## PRODUCT / PROCESS CHANGE INFORMATION

1.1 Company		STMicroelectronics International N.V
1.2 PCI No.		MDG/17/10572
1.3 Title of PCI		New Tape Header finishing procedure for EEPROM in WLCSP
1.4 Product Category		EEPROM in WLCSP
1.5 Issue date		2017-11-21

## New Tape Header finishing procedure for EEPROM in WLCSP

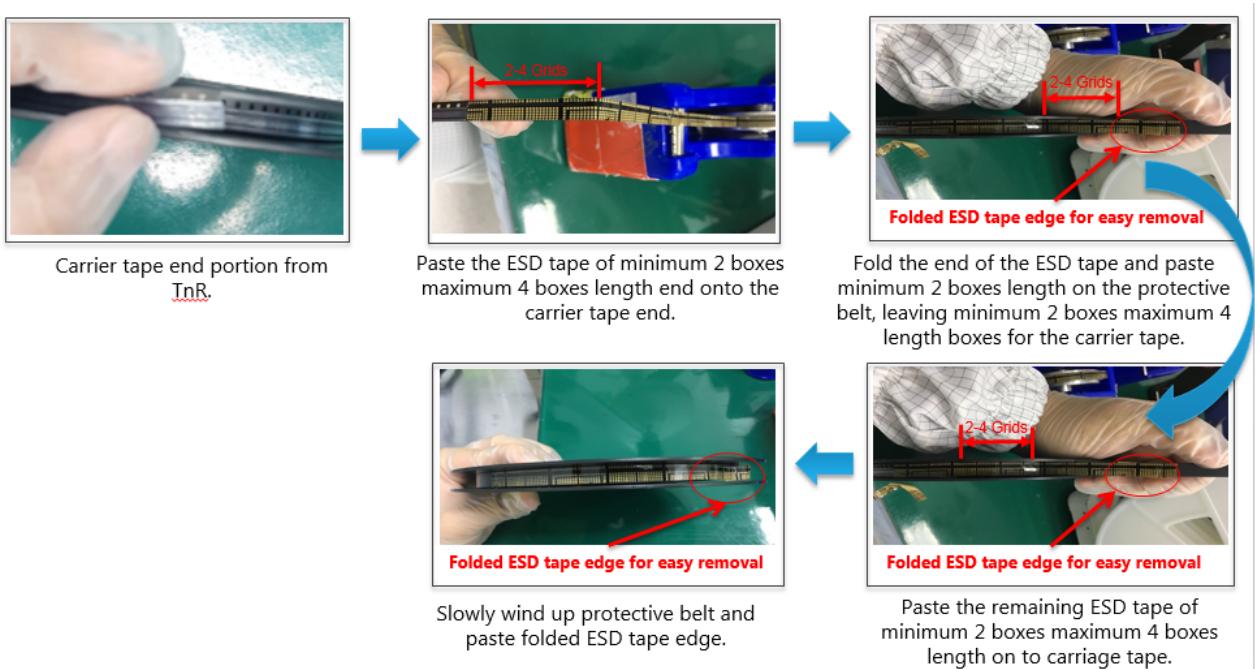
- In the **current situation**, the **header is linked to the protective belt**. Then placing (at finishing step) or removing (at customer unreeling step) the protective belt could induce tension to the tape.

- With the **new procedure**, the **header is linked to itself and pasted to the protective belt** (with the same ESD tape). Then, removing the protective belt will have less tension on the tape.

With the **new procedure**, placing or removing the protective belt will avoid potential tension to the tape at STATSChipPAC finishing or at unreeling step at customer.
